Sheet: /opamp_amp/
File: opamp_amp.kicad_sch

Sheet: /rx2/
File: rx.kicad_sch

Sheet: /clock/
File: clock.kicad_sch

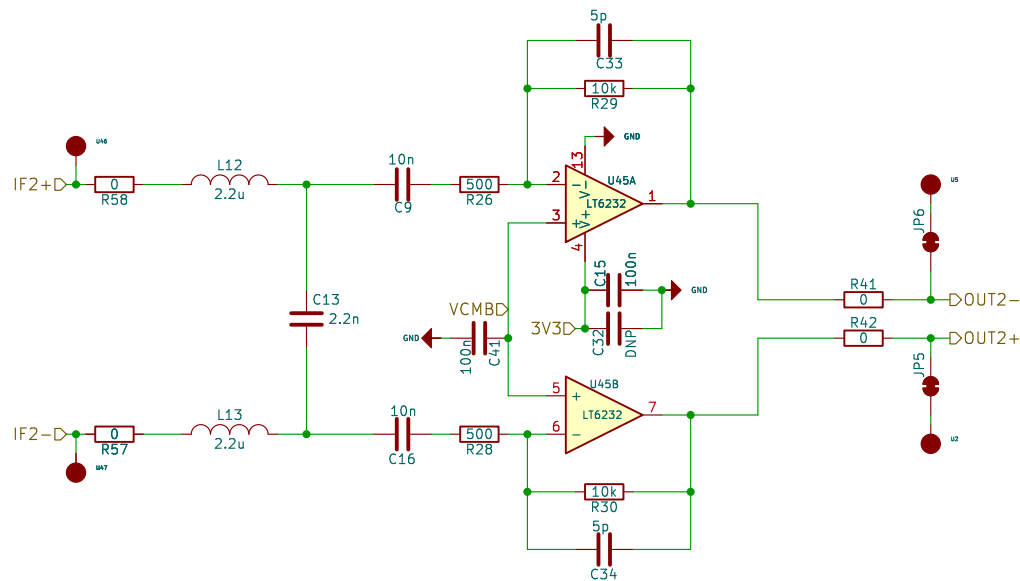
FPGA FIR Filter works perfectly.
Second stage for HPF
range compensation filter is removed

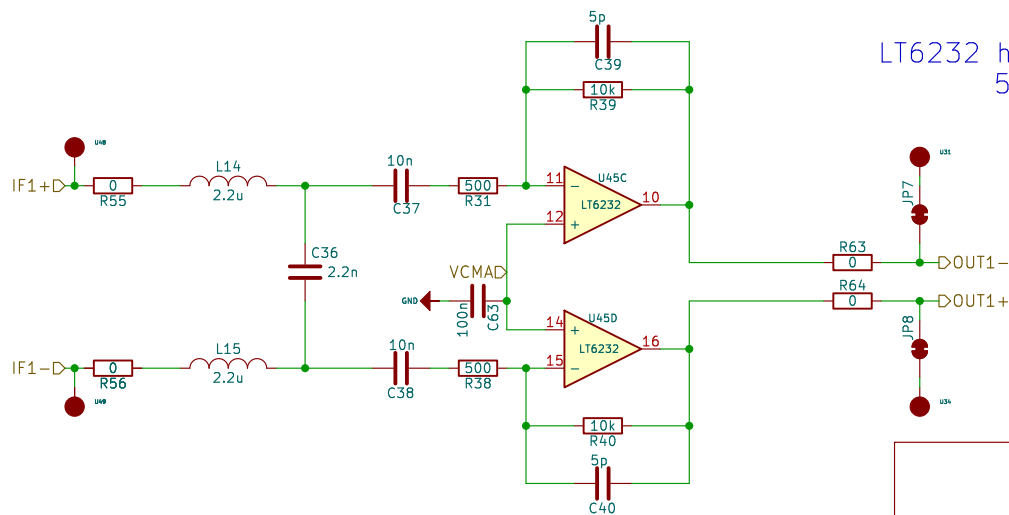
LT6232 has better noise performance as $1.1\text{nV}/\sqrt{\text{Hz}}$
500 10K has less noise contribution

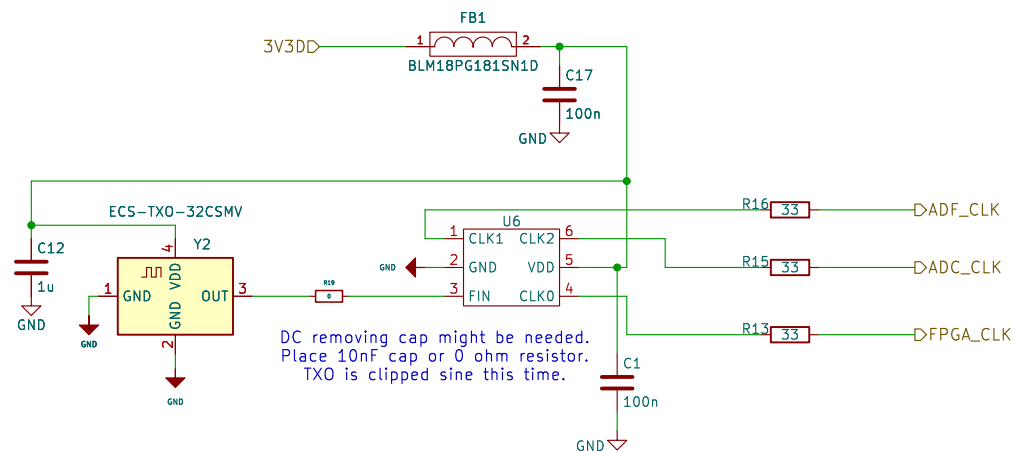
This is the prev design:
NB3N551 is obs.
Also this txo is generating pure sin.
ADC might need cmos like input not sin.
That could be the reason of duty stabilizer.
